FORESTSIDE TOWNHOUSES

SITE INSTRUCTION # 4

Date: May 21st, 2021

JAP Project No: 19066

Job No: 19066 Sheet No: S-101A

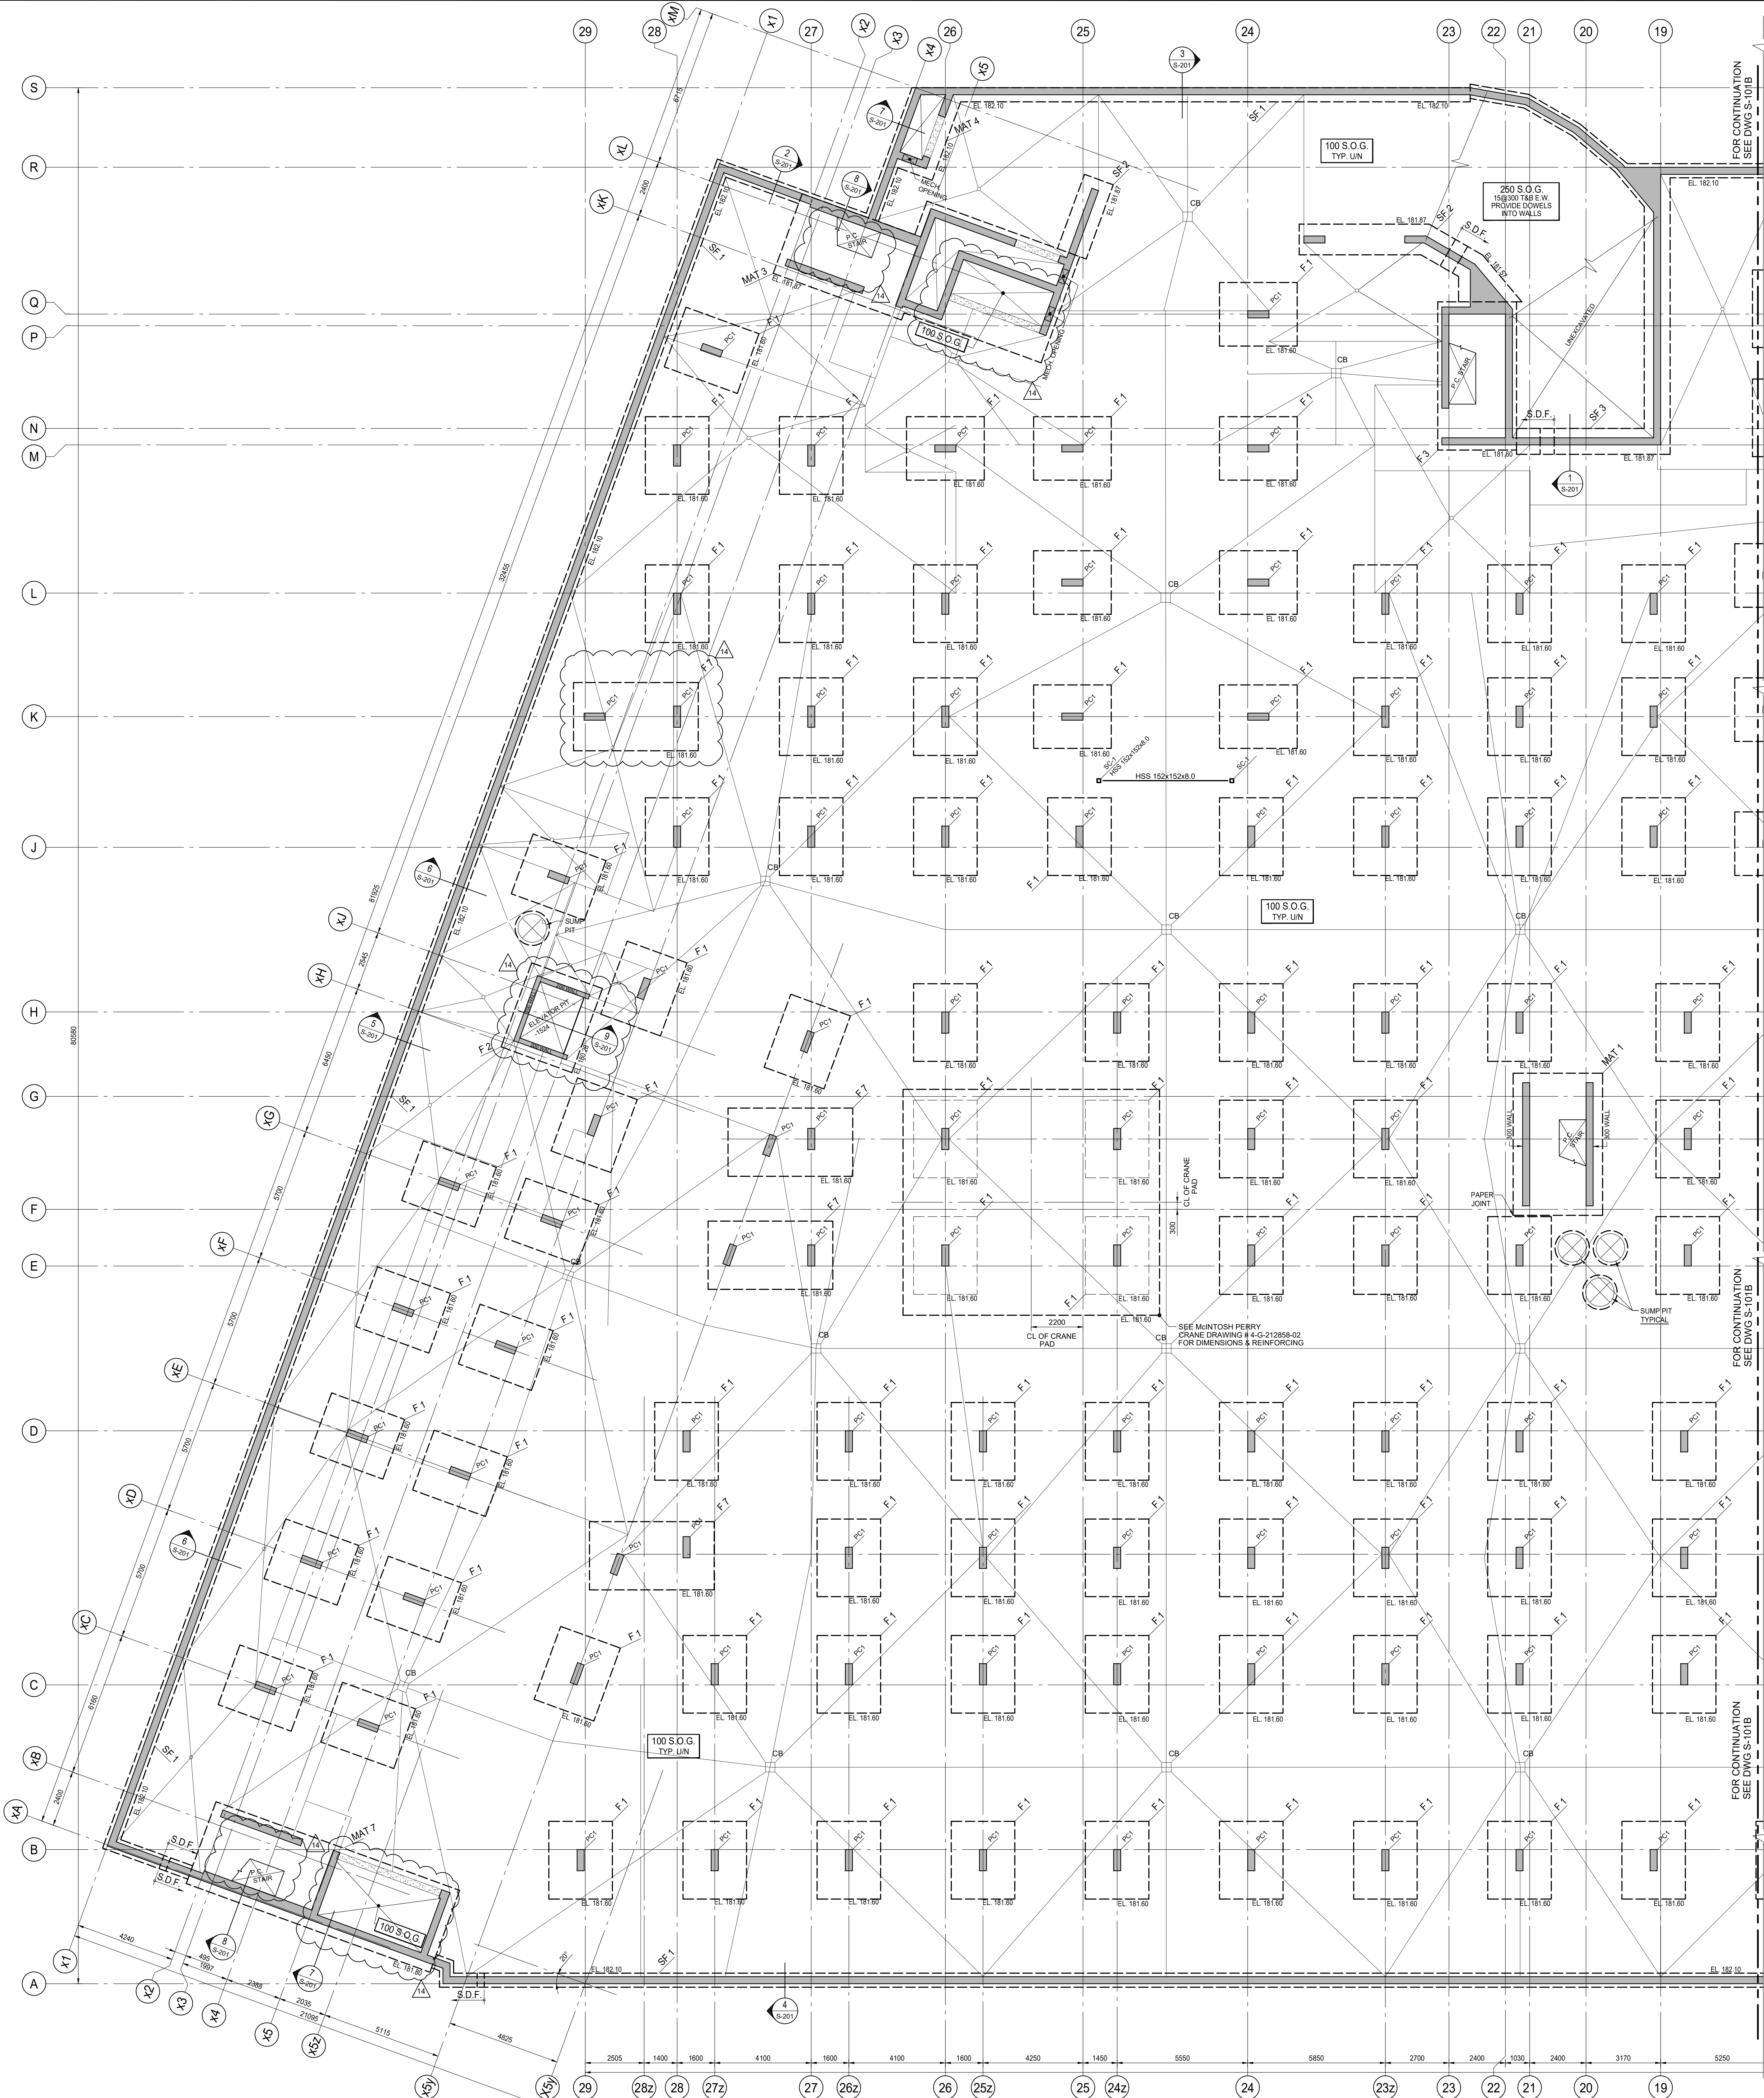
1.1 **Refer to Drawing S-101A & B "P1 UNDERGROUND"**

- a) Updated footing elevations at elevator pits
- b) Updated footing elevations on perimeter
- c) Corrected SOG labels
- d) Updated to show missing F-7 (layer was turned off)
- e) Updated location of precast stairs to match arch

Date Plotted:	Date:	May 20 2021
Drawn By:	ND	Scale: 1 : 100
Checked By:	JW	Revision Number:
Job No:	19066	Sheet No:
		S-102B

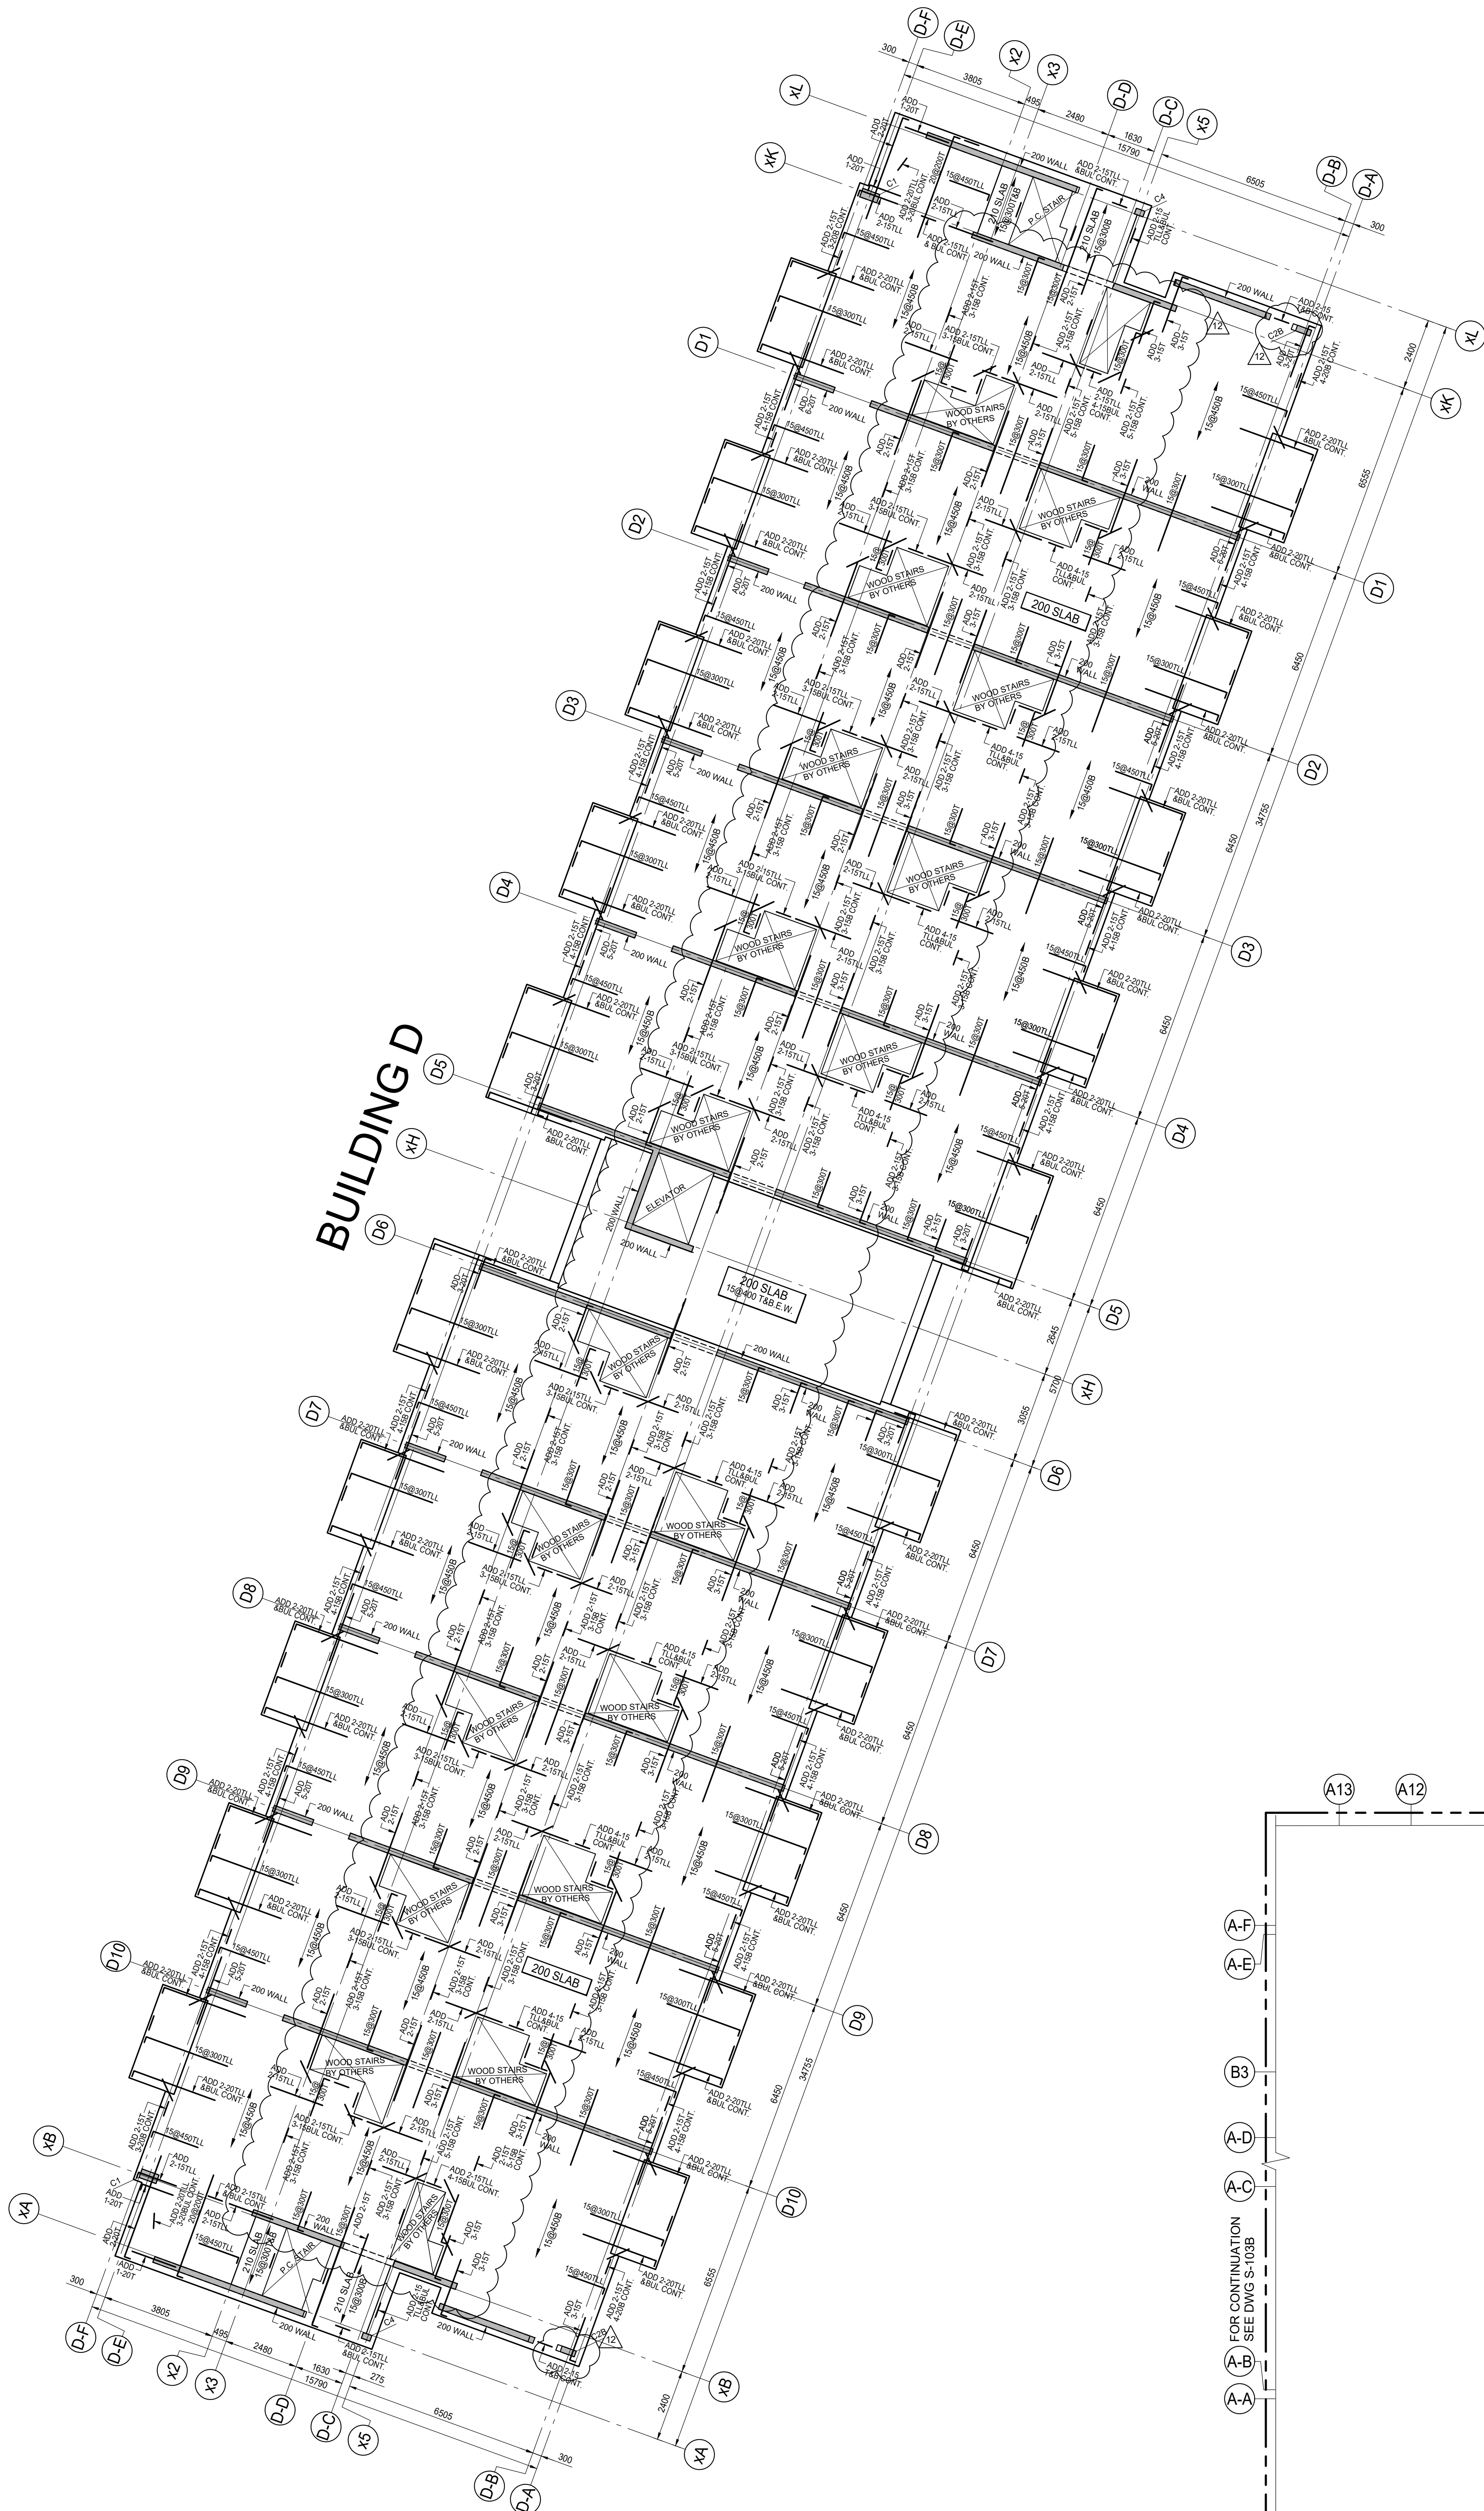
1.2 **Refer to Drawing S-102A & B "GROUND FLOOR FRAMING PLAN"**

- f) Updated to match architectural walls extents in Building D
- g) Updated extent of 500 slab as bubbled
- h) Updated rebar on GF at locations bubbled
- i) Showed midlanding for all stairs
